M274 Check engine light, P052E71 Crankcase ventilation valve

Topic number	LI01.20-P-076894
Version	8
Function group	01.20 - Crankcase ventilation, cylinder head cover
Date	4/15/25
Validity	Passenger car with engine M274
Reason for change	Addition of operation codes

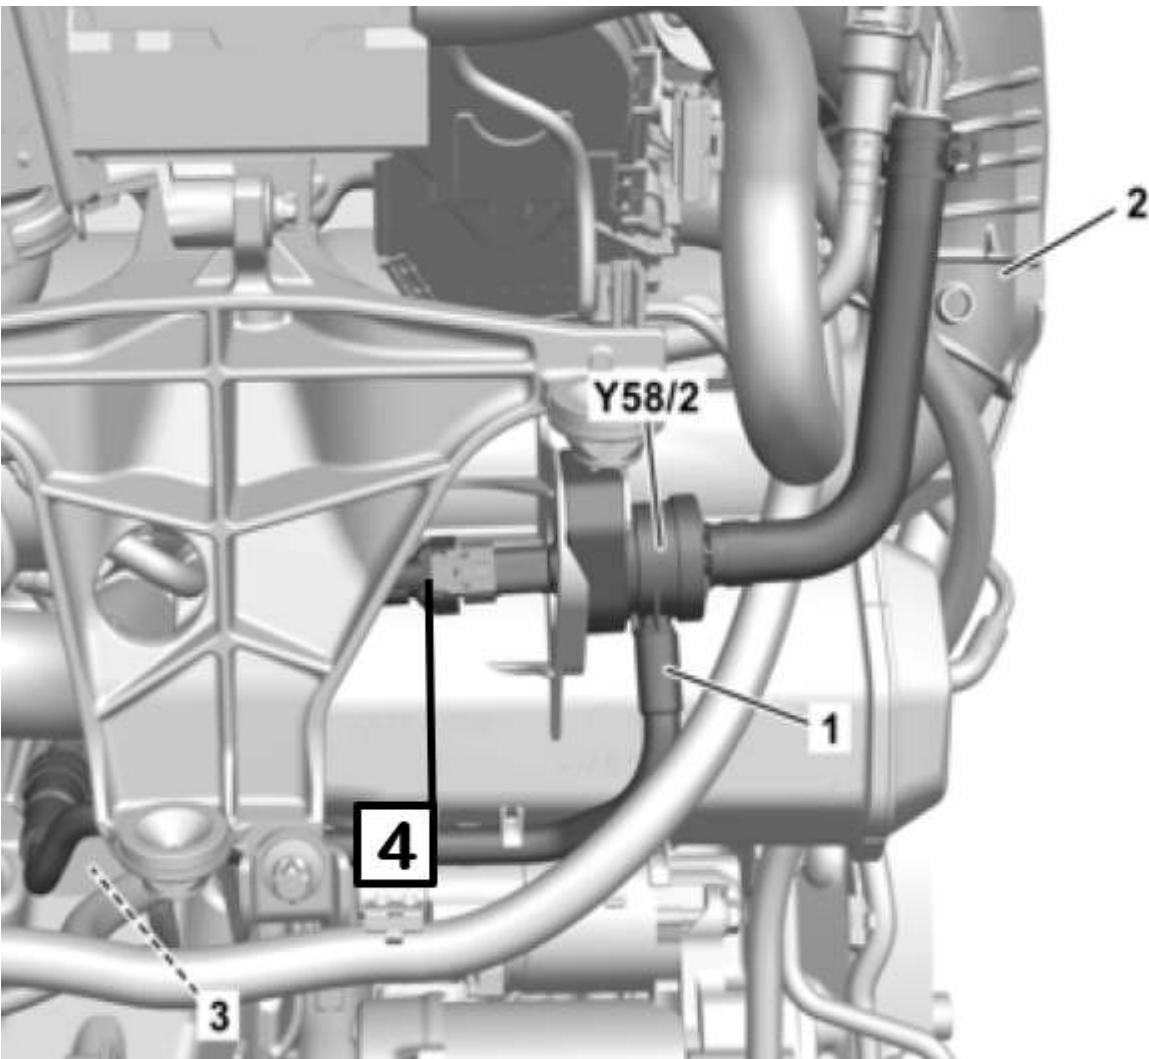
- 1- Perform software update for N3/10 Engine control unit.
- 2- Remove upper engine cover.
- 3- Unclip ME-SFI control unit (N3/10) with bracket and place to one side with connected lines (see AR07.08-P-7013M-RD).
- 4- Release and disconnect electrical connector (4) of partial-load operation crankcase ventilation valve (Y58/2).
- 5- Fit cap A094 545 50 03 on electrical connector (4) of engine wiring harness partial load operation crankcase ventilation valve (Y58/2) and ensure correct seating on plug of electrical connector (4).

6- Strap down electrical line (4) of partial load operation crankcase ventilation system valve (Y58/2) at wiring harness. Ensure that electrical line (4) is routed free of tension.
